**Economic and Social Council**Distr.: General
25 February 2016

Economic Commission for Europe**Inland Transport Committee****World Forum for Harmonization of Vehicle Regulations****Working Party on Passive Safety****Fifty-ninth session**

Regulation No. 129 (Enhanced Child Restraint Systems)**Proposal for Supplement 05 to Regulation No. 129 (Enhanced Child Restraint Systems)****Submitted by the expert from the European Association of Automotive Suppliers***

The text reproduced below was prepared by the expert from the European Association of Automotive Suppliers (CLEPA) to update the references to the European standard on toxicity and flammability of materials used to manufacture Child Restraint Systems (CRS). This text is based on informal document GRSP-58-32 distributed during the fifty-eighth session of the Working Party on Passive Safety (GRSP). The modifications to the current text of UN Regulation No. 129 are marked in bold for new characters.

Figure 1

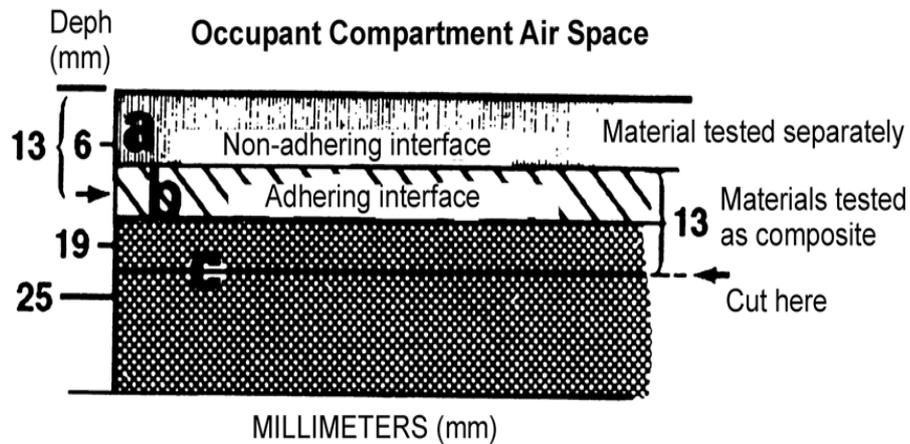
2. Material selection (see Figure 1 below)

2.1. Any portion of a single or composite material which is within 13 mm of the occupant compartment air space shall meet the requirements in paragraph 6.1.6.

2.1.1. Any material that does not adhere to other material(s) at every point of contact shall meet the requirements of paragraph 6.1.6. when tested separately

2.1.2. Any material that adheres to other materials at every point of contact shall meet the requirements of paragraph 6.1.6. when tested as a composite with the other material(s).

Material A has a non-adhering interface with material B and is tested separately.

Part of material B is within 13 mm of the occupant compartment air space, and materials B and C adhere at every point of contact; therefore, B and C are tested as a composite.

The cut is in material C as shown in Figure 1, to make a specimen 13 mm thick.

Figure 2
All dimensions in millimeters (mm)

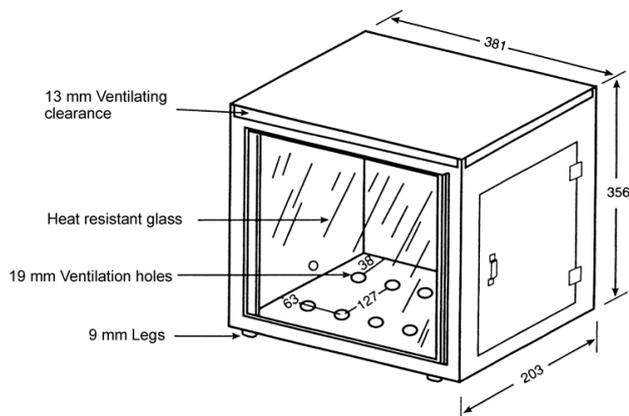
3.1 The test is conducted in a metal cabinet for protecting the test specimens from drafts. The interior of the cabinet is 381 mm long, 203 mm deep, and 356 mm high. It has a glass observation window in the front, a closable opening to permit insertion of the specimen holder, and a hole to accommodate tubing for a gas burner. For ventilation, it has a 13 mm clearance space around the top of the cabinet, ten holes in the base of the cabinet, each hole 19 mm in diameter and legs to elevate the bottom of the cabinet by 10 mm, all located as shown in Figure 2.

3.3. The test specimen is inserted between two matching U-shaped frames of metal stock 25 mm wide and 10 mm high.

The interior dimensions of the U-shaped frames are 51 mm wide by 330 mm long.

3.4. A bunsen burner with a tube of 10 mm inside diameter is used.

The gas adjusting valve is set to provide a flame, with the tube vertical, of 38 mm in height. The air inlet to the burner is closed.
